THE CLEVELAND ELECTRIC ILLUMINATING COMPANY

PY-CEI/NRR-0327 L

Perry Nuclear Power Plant
Docket Nos. 50-440; ~~50~~-441
NUREG 0737 - II.F.1
(Attachments 1 & 2)
& II.B.3 Implementation
and Clarifications

GASEOUS EFFLUENT SAMPLING SYSTEMS: REPRESENTATIVENESS & DESIGN CHANGES

ECN 27978-~~8~~-1910 REV. B
ATTACHMENT # 12

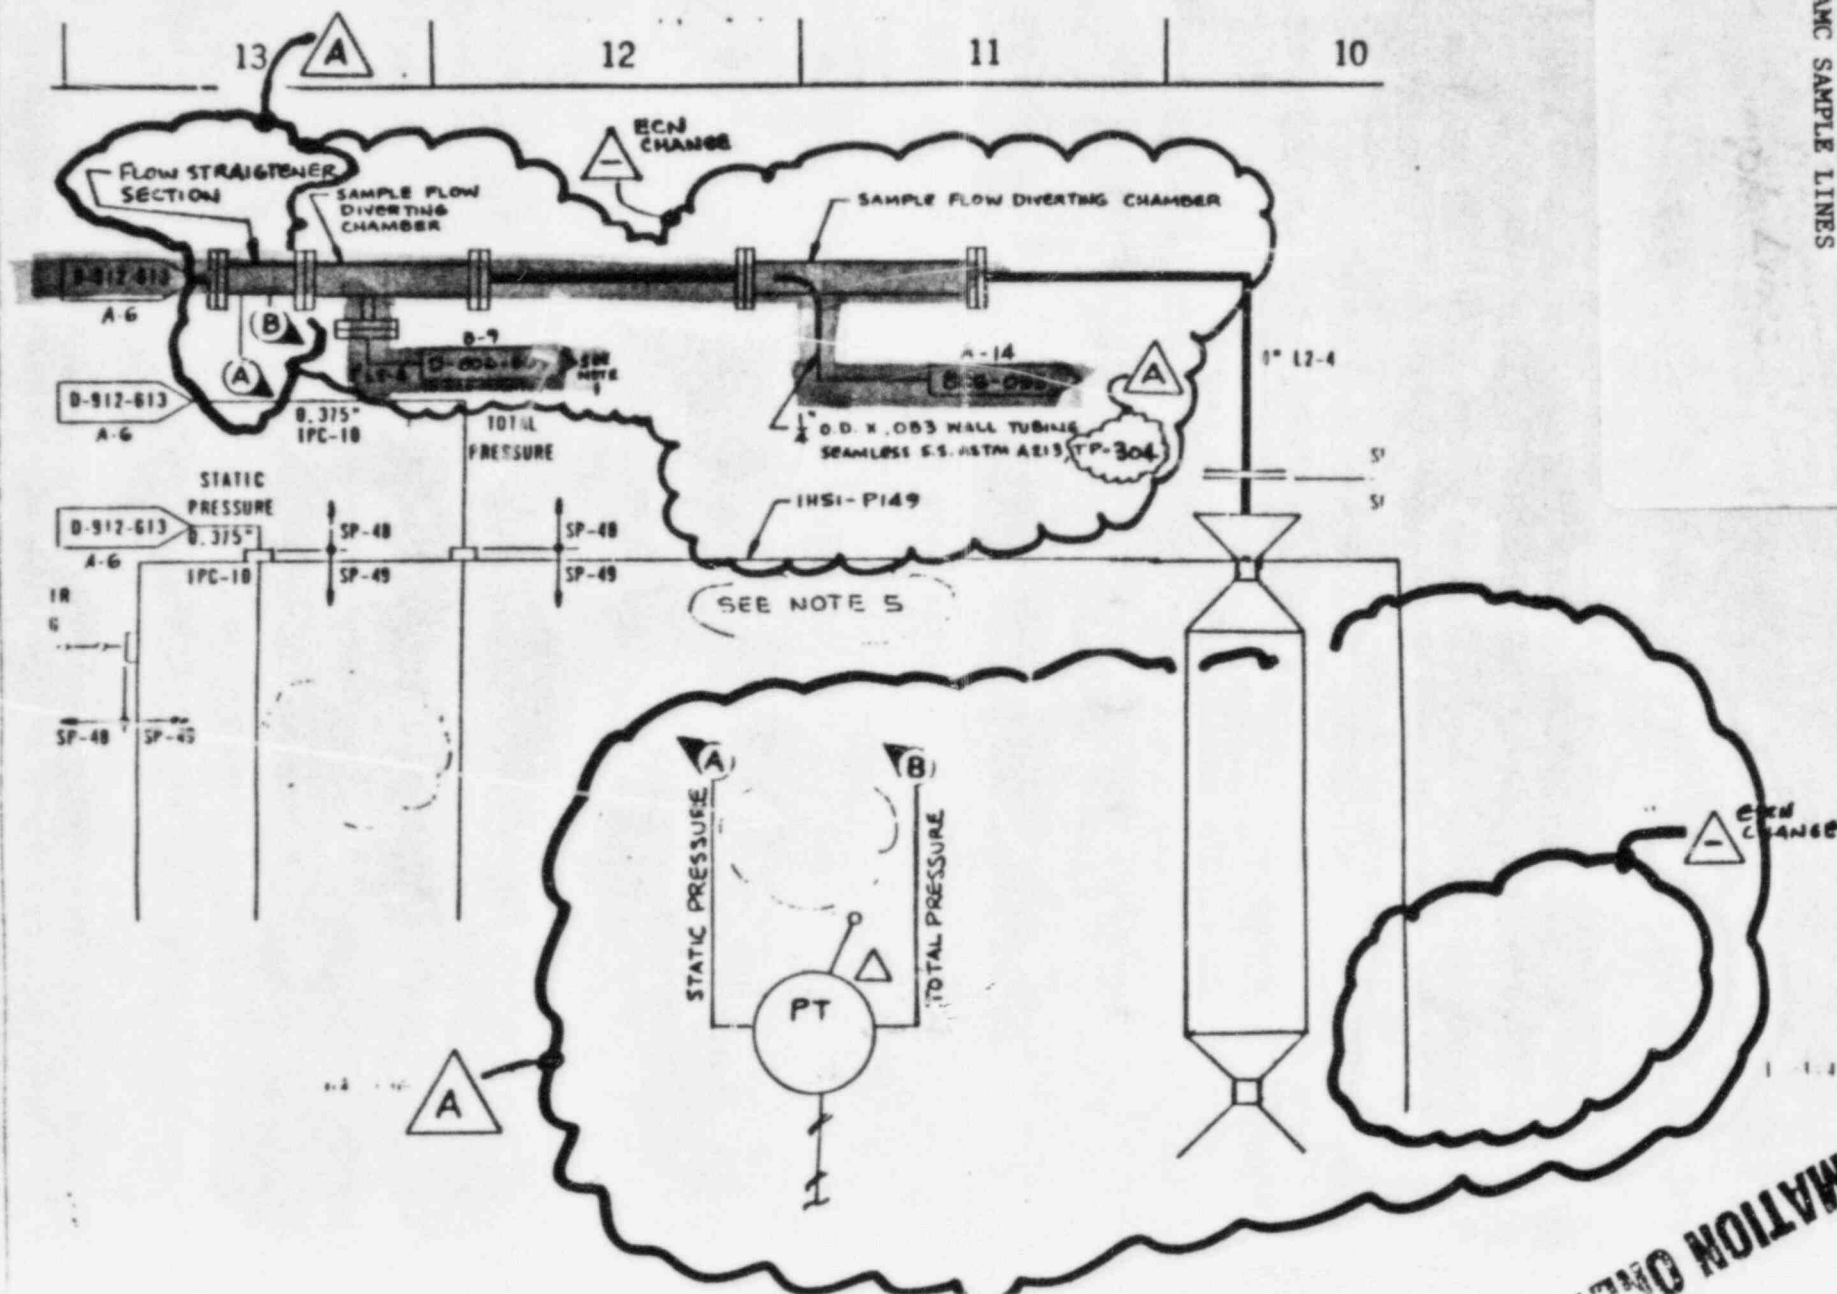
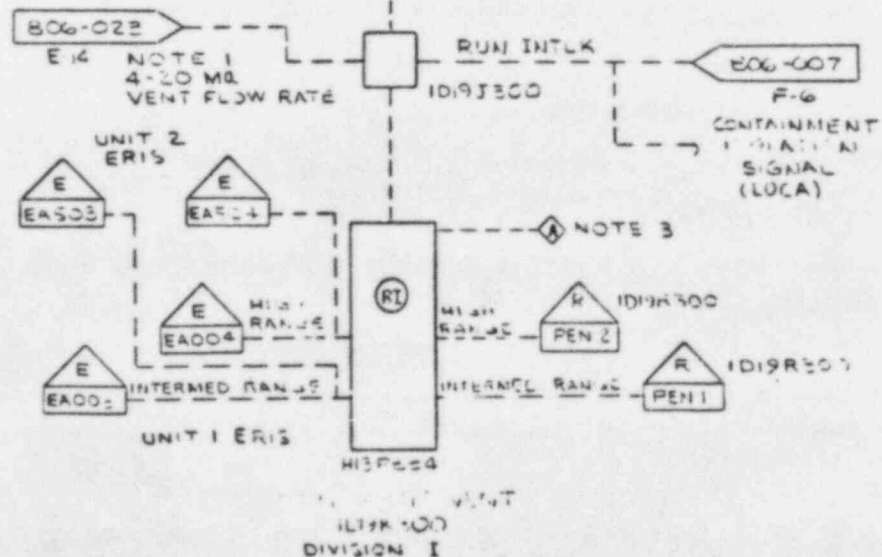
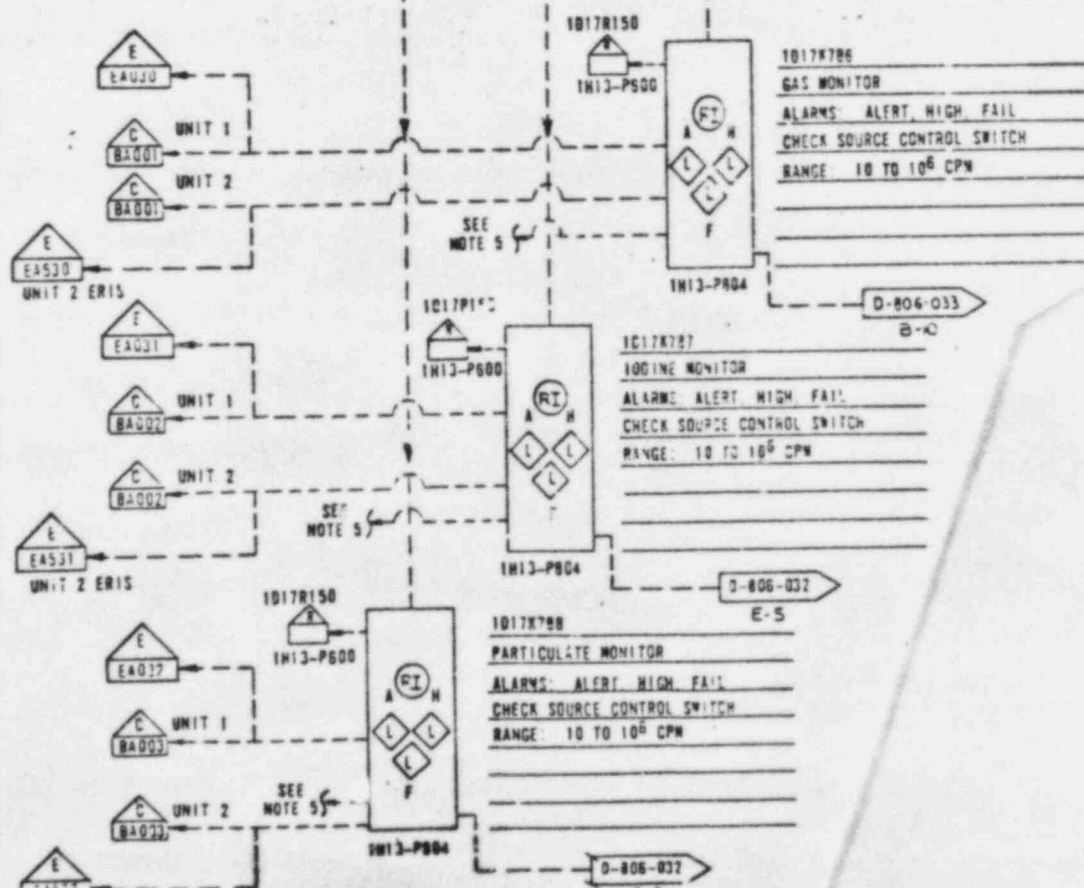
- A. The NRC sample panels have been deleted from service. Three P/I collectors on the Kaman skid will be used in conjunction with the normal range radiation monitor P/I collectors in order to continuously collect P/I samples through the required range.
- B. The AMC sample lines have been routed to the Kaman post-accident skids where a secondary sample will be extracted such that the isokinetic condition is maintained at expected operating vent flow. The secondary sample will be transported via nominal 0.25" OD tube, designed such that the length of the tube is as short as practicable.
- C. All gaseous effluent inlet sampling lines (both normal and post-accident range) will be heat-traced and insulated in order to overcome sample line heat loss and therefore reduce the possibility of condensation as the sample stream passes through particulate and iodine filters.

* System description excerpts are included, along with a highlighted P&I diagram, to reflect these changes.
